REQUEST FOR FURTHER INFORMATION RESPONSE DOCUMENT
FOR ADAMSTOWN SDZ PLANNING APPLICATION:
ADERRIG PHASE 3
MARCH 2022

CONTENTS

Unit Type: E2

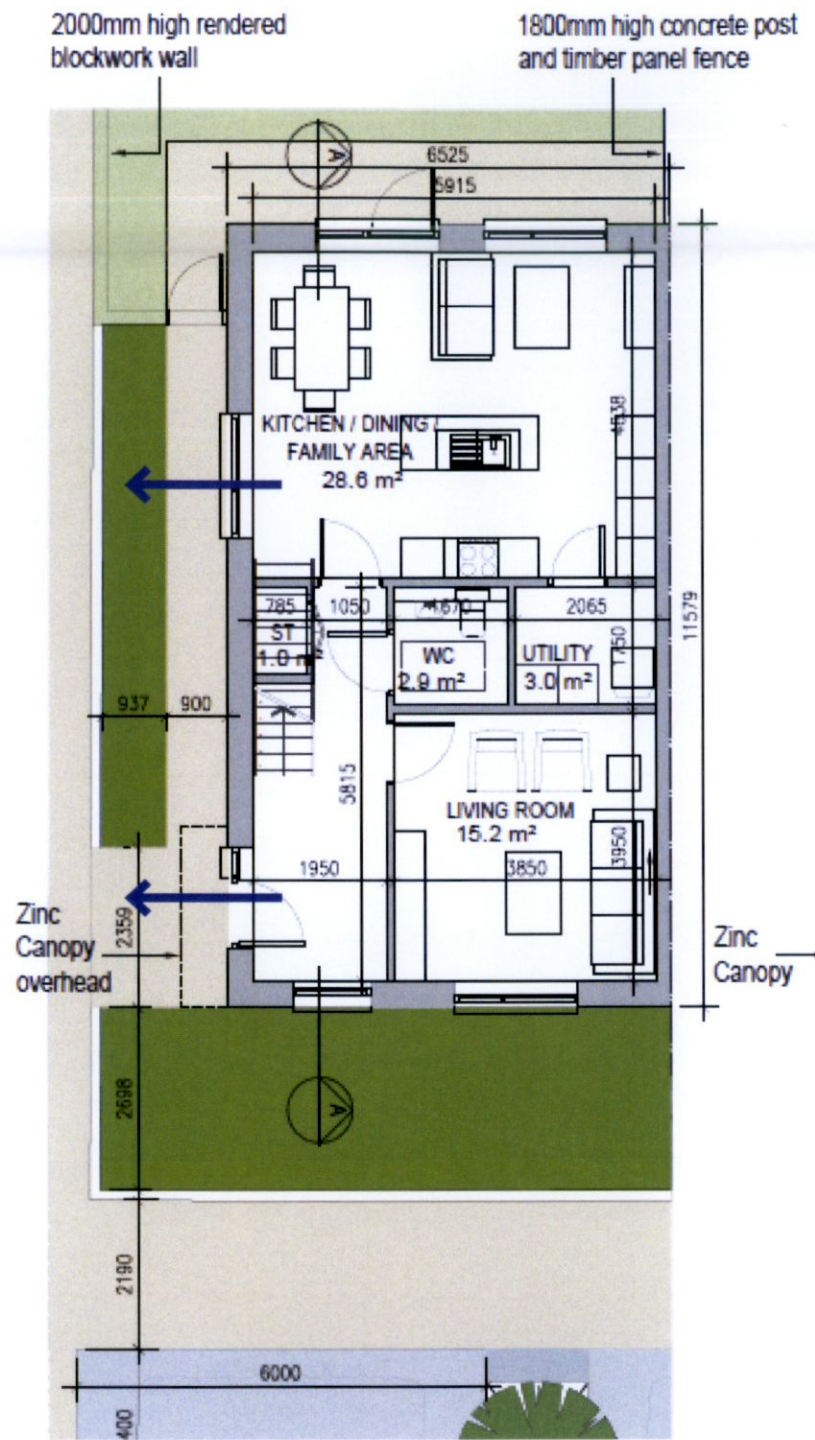
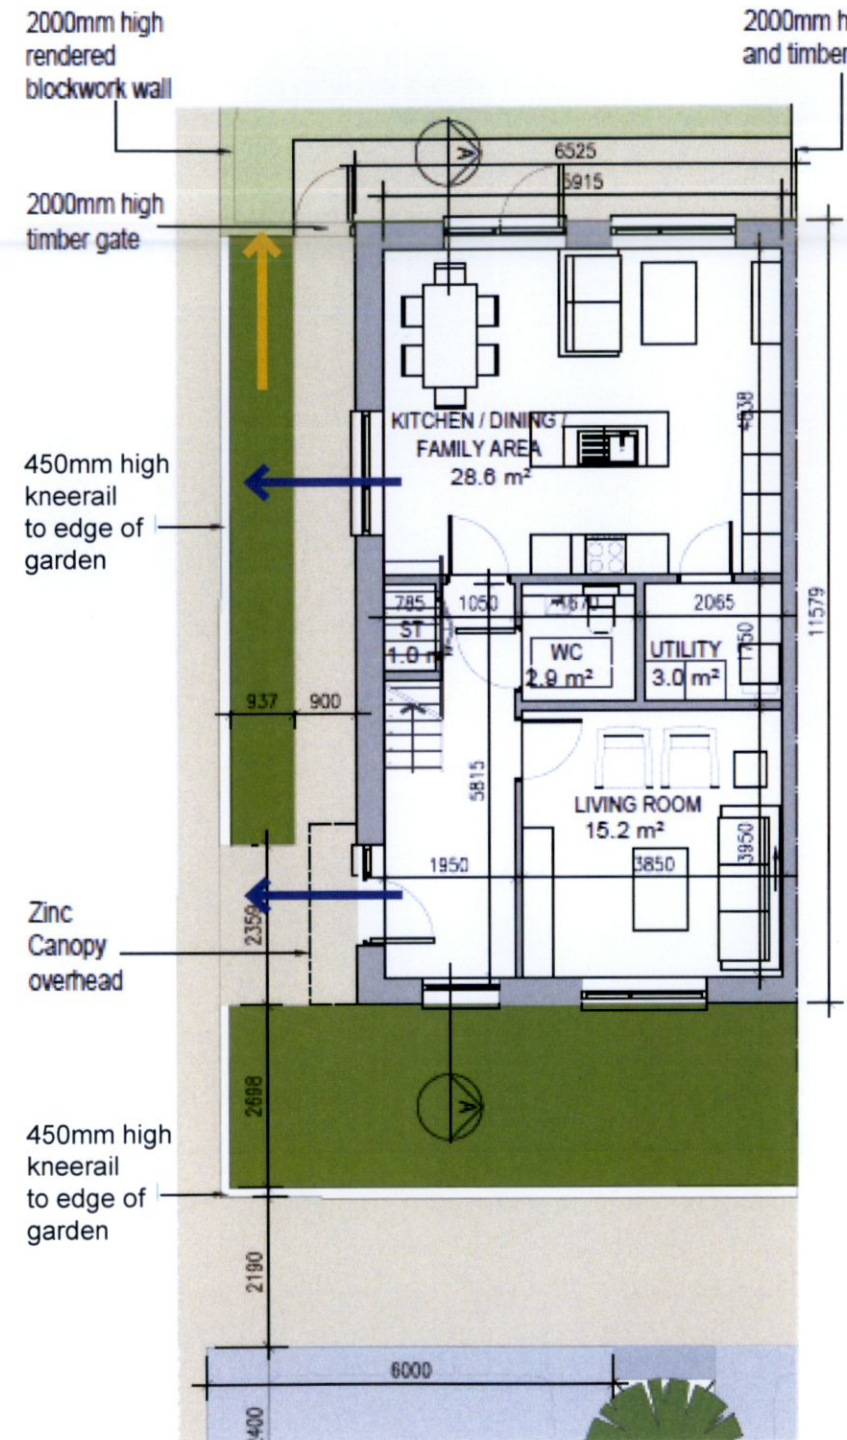
- A2
- E2
- K1

The original application drawing for E2 may have been read as having a garden wall, whereas it's actually only a 900mm high railing which will allow passive surveillance through/over it.

-  Passive surveillance
-  Garden wall pulled back to improve passive surveillance opportunity

2.d Homezones 1 & 2

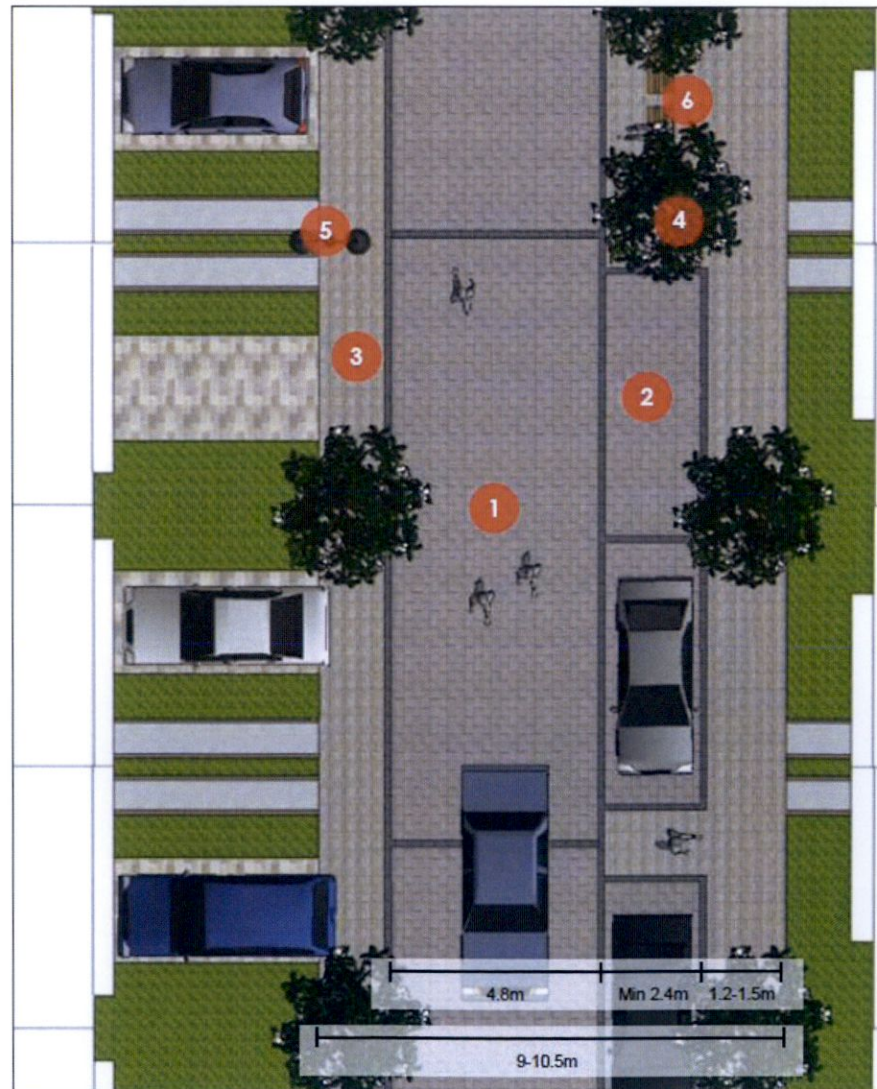
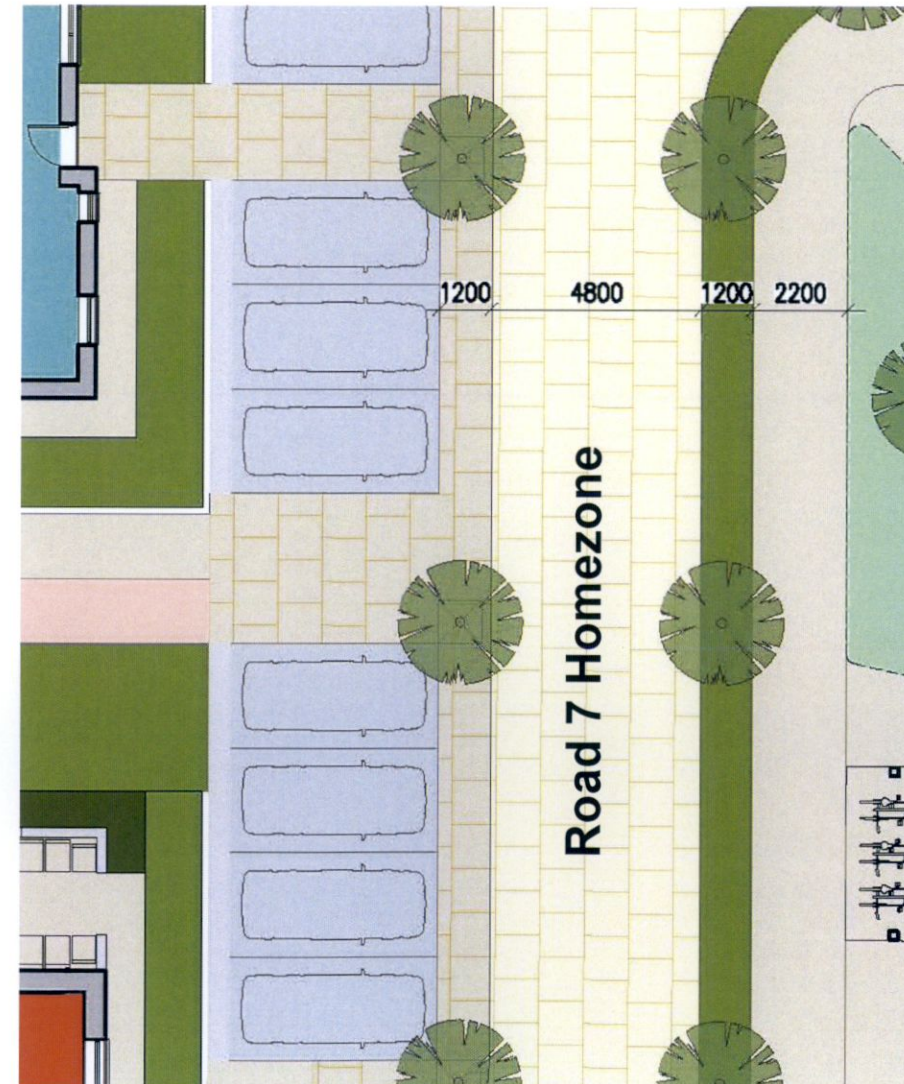
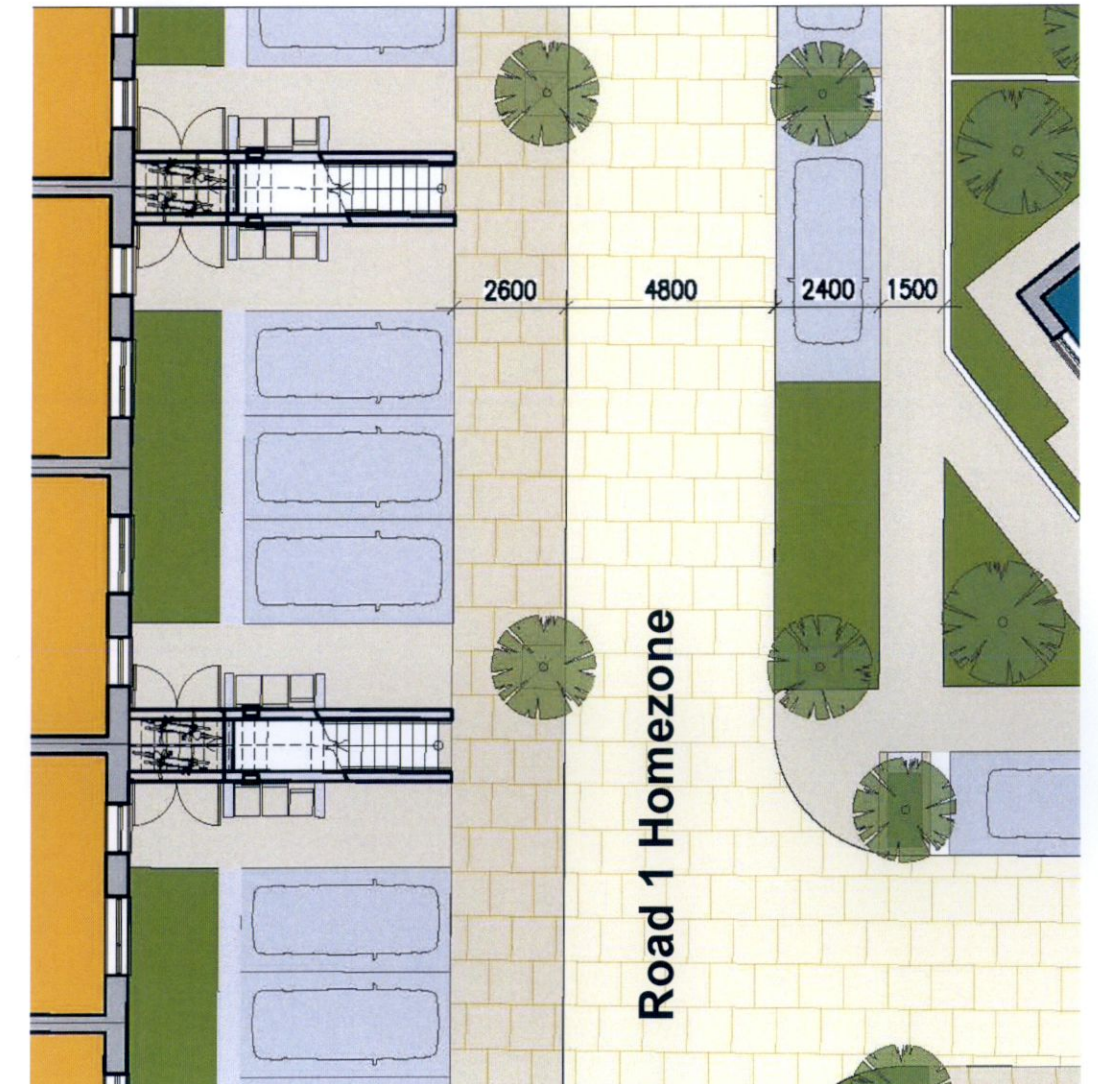
2.d. There are concerns regarding the layout of Homezone 1 and Homezone 2. These are taken to correspond to the 'Back Street' typology. The applicant is requested to redesign these areas in accordance with the Adamstown Street Design Guide.

The layout of all Homezones throughout the site have been adjusted to conform with the ASDG section 6.4.3 'Back Street - Homezone'.

Please note, as part of the site revisions some road names have changed:

('Homezone 1' is now labelled as 'Road 7 Homezone')

('Homezone 2' is now labelled as 'Road 1 Homezone')

Proposed Local Park - Road 7 (Previously labelled as 'Homezone 1')

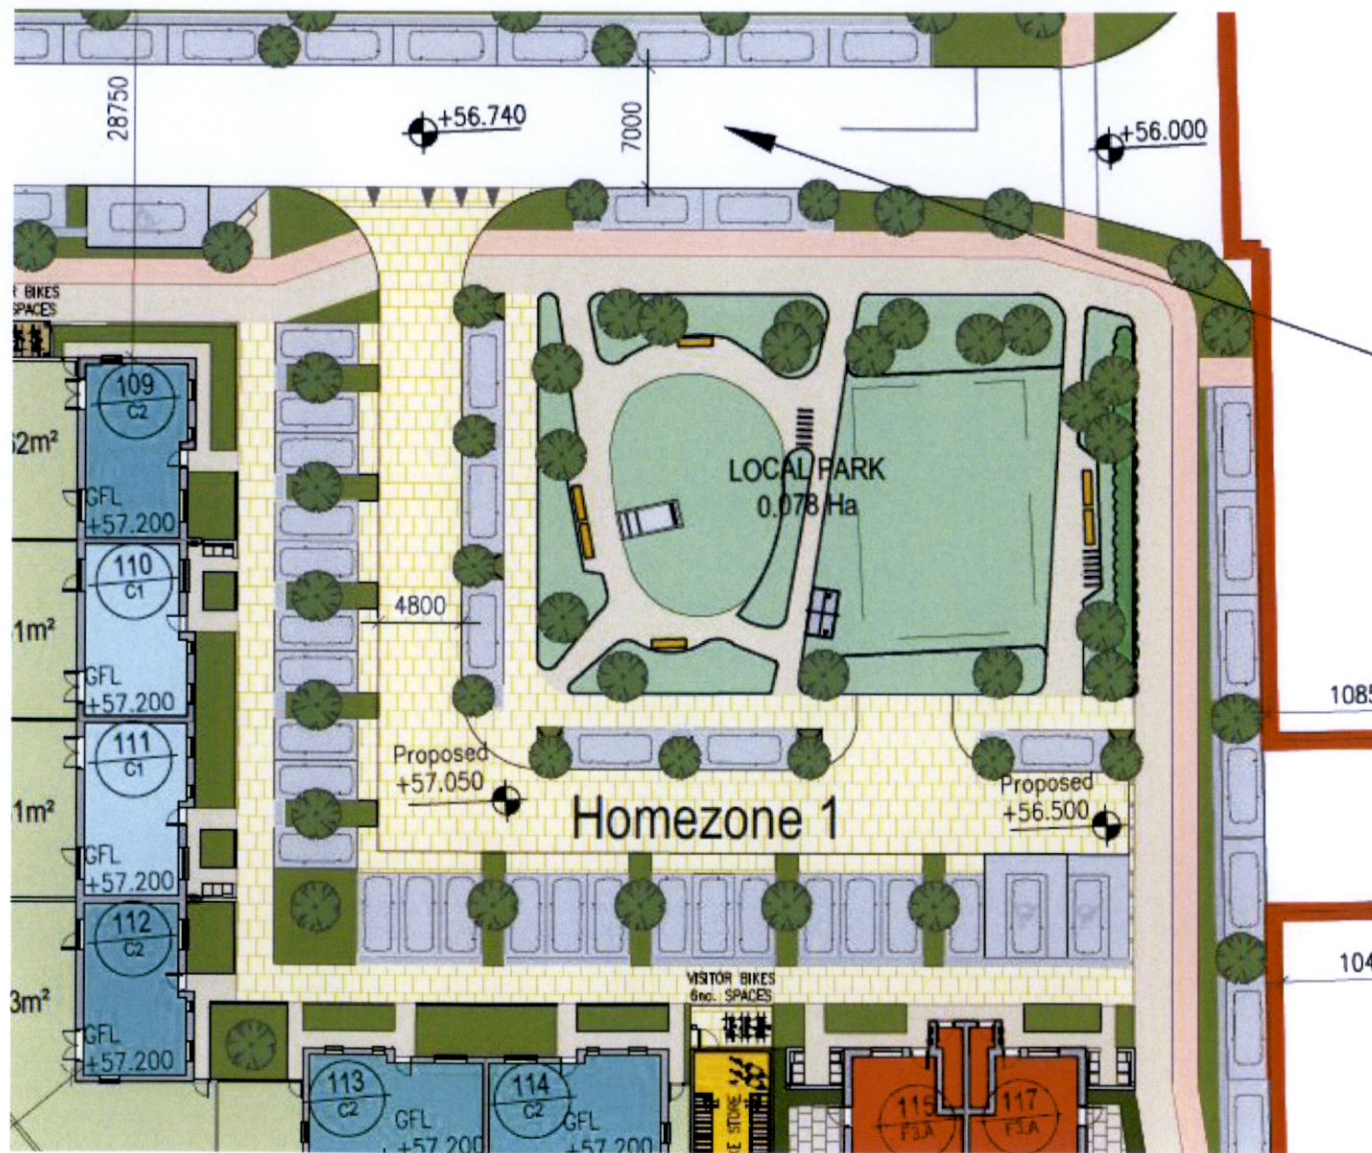
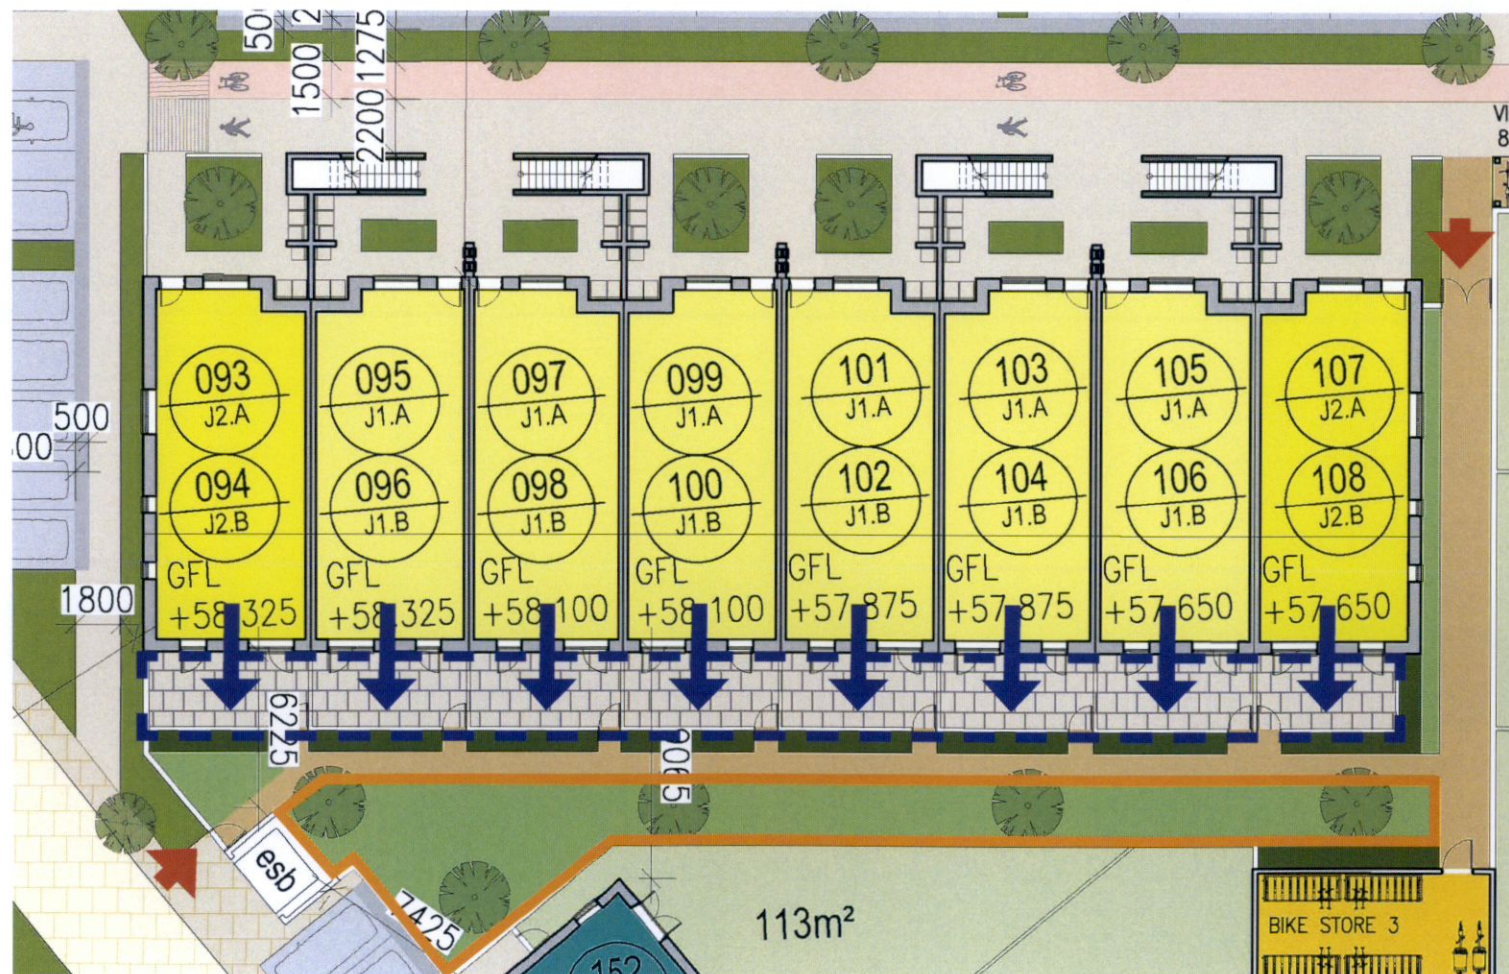
2.e. It is noted that car parking is provided around the open space to the south east. The applicant is requested to remove the car parking to the south and west of this park.

The previous parking shown to the south and west of the Local Park has been removed as suggested. The road layout has been adjusted to match the Back Street - Homezone diagram as shown in the ASDG section 6.4.3. and to adjust the turning head to the east. This results in an increase to the area of the park from 0.078ha to 0.087ha.

Duplex Units no.'s: 093 - 108, Adamstown Way

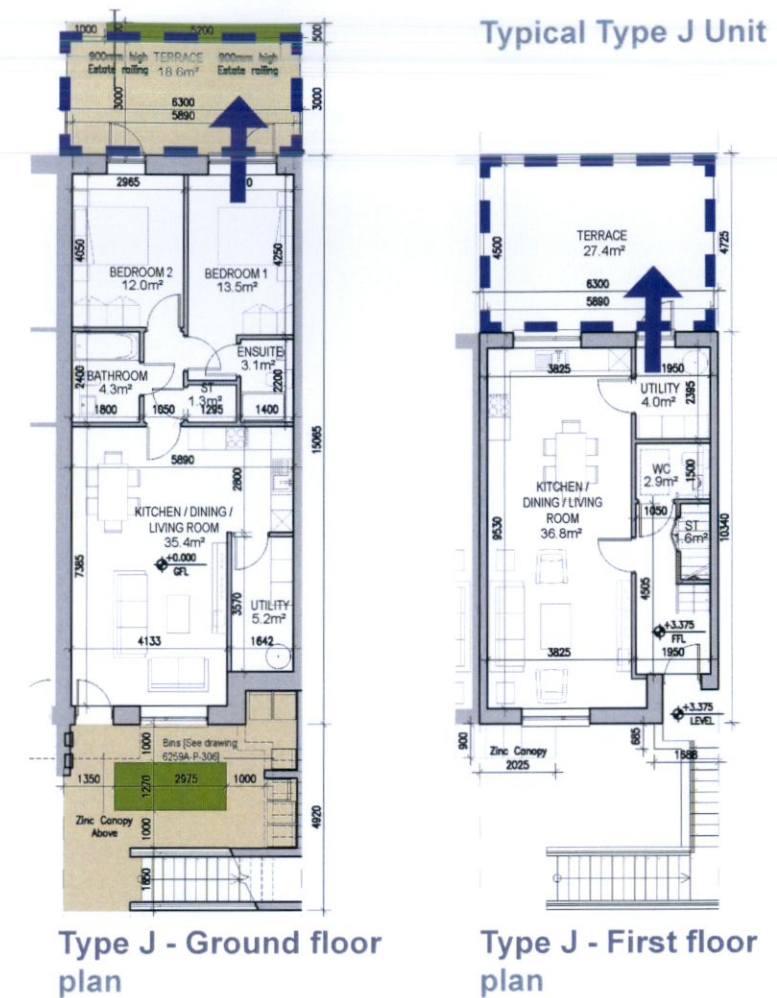
2.f. In terms of communal open space, it is noted that 3 areas are provided. The applicant states in their Planning Statement that it was not possible to provide dedicated communal open spaces in all instances. In these cases larger private open spaces are provided. There are concerns regarding the functionality of some of the communal spaces, particularly those at Unit Type J and F. These areas are linear with areas of planting and hardstanding. The applicant is requested to provide a clear plan indicating which properties benefit from the additional private amenity areas and also which properties are intended to avail of the communal open spaces.

All duplex units meet the requirement for both private open space and communal open space within their own private amenity areas accessed from their units. Each terrace has been oversized to accommodate both provisions (private & communal space).

The shared open spaces, where shown to the rear of the duplex units, provide further amenity space in addition to the total required open space fully provided within the curtilage of each unit. No units rely on these shared areas to meet their open space requirements. While the shared open spaces shown are not required to meet a certain area / function, we have updated these areas to represent more green usable space.

Additional open space for the enjoyment of all residents of units 093-108, c.146sqm [not required to fulfill the communal open space requirement]
This open grassy area will be planted with some trees with a resin bonded pathway running alongside it, enclosed by a 2m high rendered blockwork wall with gated access off both Adamstown Way and Road 8. Low hedging and a 900mm estate railing with gates, close off this shared space with the private terraces to the rear of the units.
Please refer to the landscape drawing 'LP-01-FI for further information.'
